SUNDRY NOTICES AND REPORTS ON WELLS
Do not use this form for proposals to drill or to re-enter an abandoned well. Use Form 3160-3 (APD) for such proposals.

EOG Resources Inc. (EOG) respectfully requests the execution of the variance for Wellhead break testing and offline cementing for the following wells, as outlined below (and with the additional Offline Cement Intermediate Operational Procedure):

Well Name: Dauntless 7 Fed Batch

**BATCH SUNDRY FOR BACKUP CASING DESIGN, OFFLINE CEMENTING AND
BREAK TESTING. ALL PREVIOUS COAs STILL APPLY**

Revised Wellbore A:

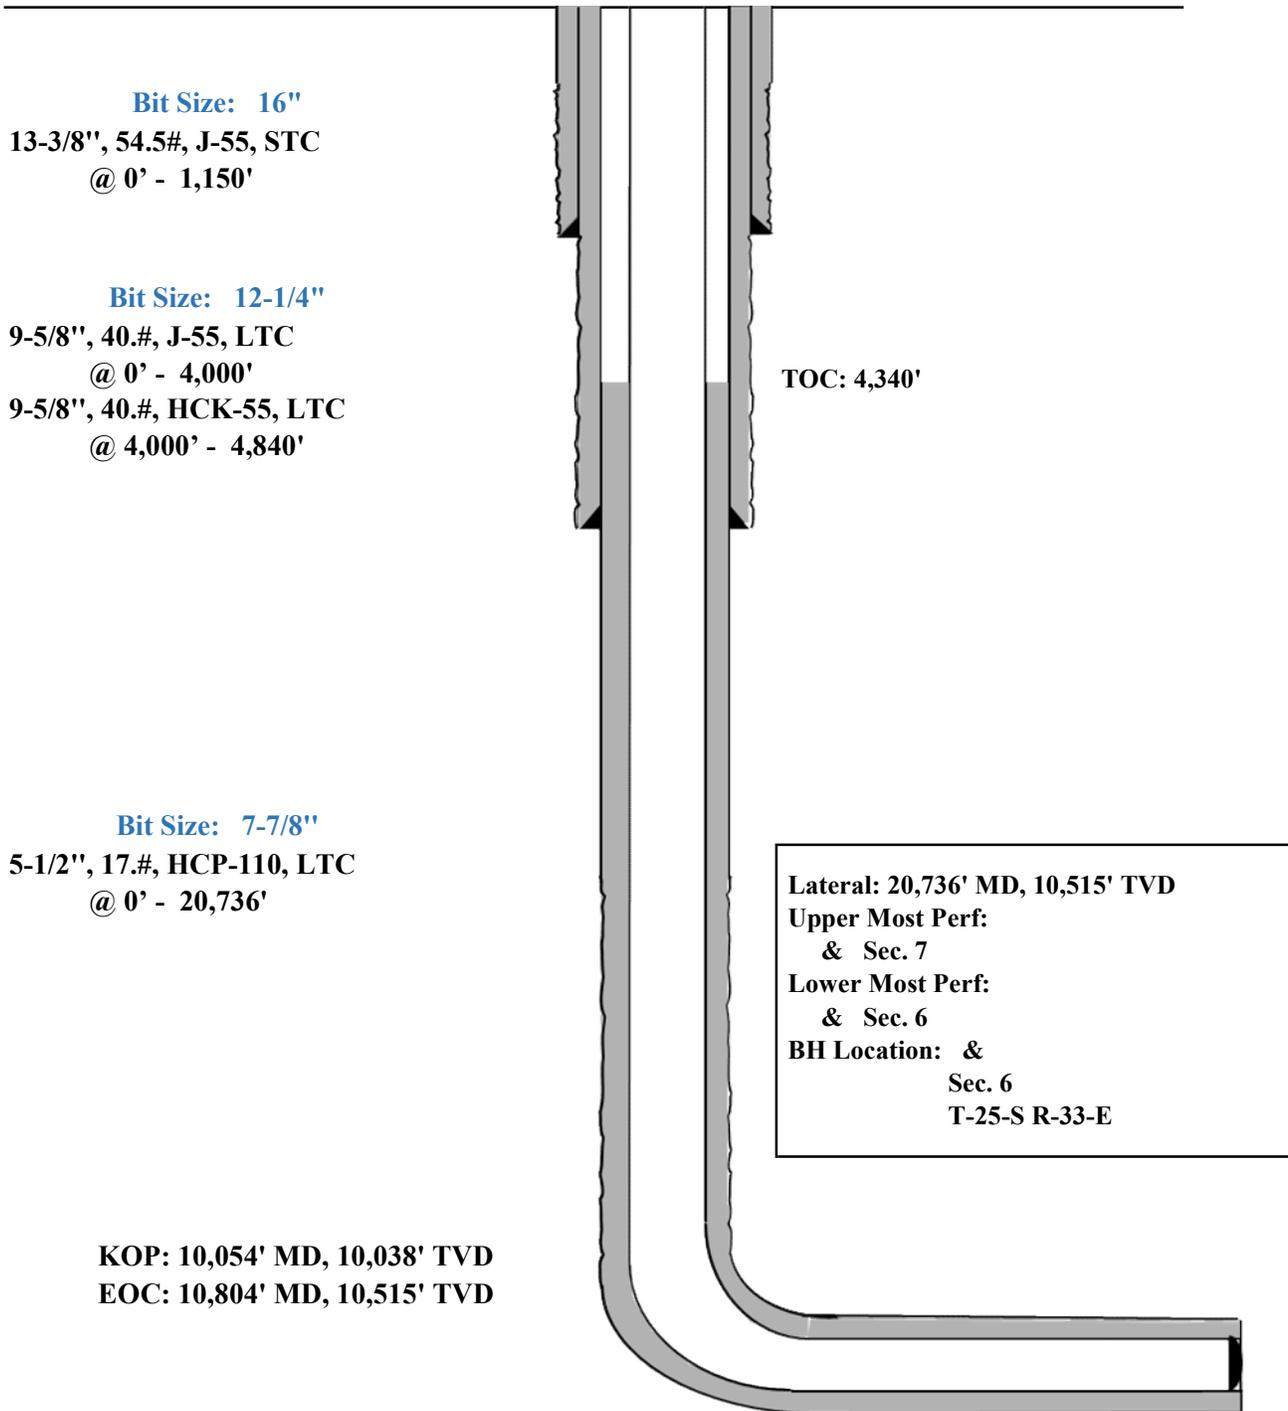
Casing Program A:

Variance is requested to waive the centralizer requirements for the 9-5/8" casing in the 12-1/4" hole size. An expansion additive will be utilized, in the cement slurry, for the entire length of the 12-1/4" hole interval to maximize cement bond and zonal isolation.

Variance is also requested to waive any centralizer requirements for the 5-1/2" casing in the 7-7/8" hole size. An expansion additive will be utilized, in the cement slurry, for the entire length of the 7-7/8" hole interval to maximize cement bond and zonal isolation.

Revised Wellbore B:

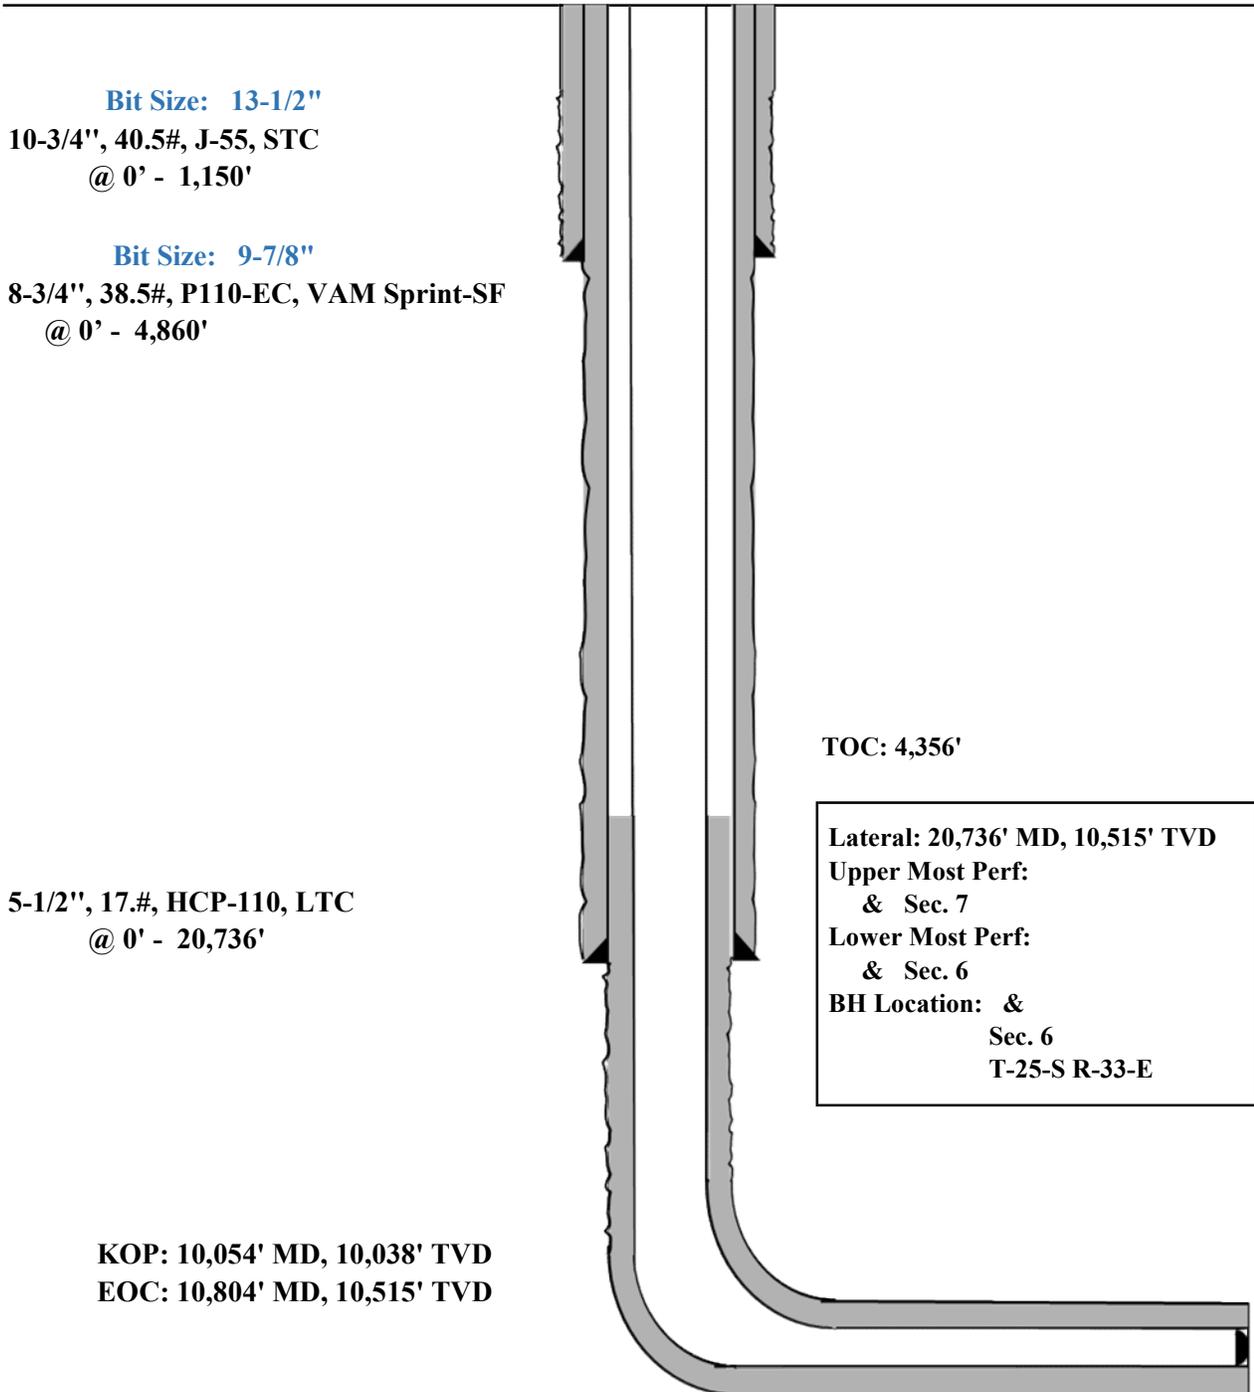
Casing Program B:

As a contingency, EOG requests to pump a two stage cement job on the 7-5/8" intermediate casing string with the first stage being pumped conventionally with the calculated top of cement at the Brushy Canyon (7,555') and the second stage performed as a bradenhead squeeze with planned cement from the Brushy Canyon to surface. If necessary, a top out consisting of 1,000 sacks of Class C cement + 3% Salt + 1% PreMag-M + 6% Bentonite Gel (2.30 yld, 12.91 ppg) will be executed.
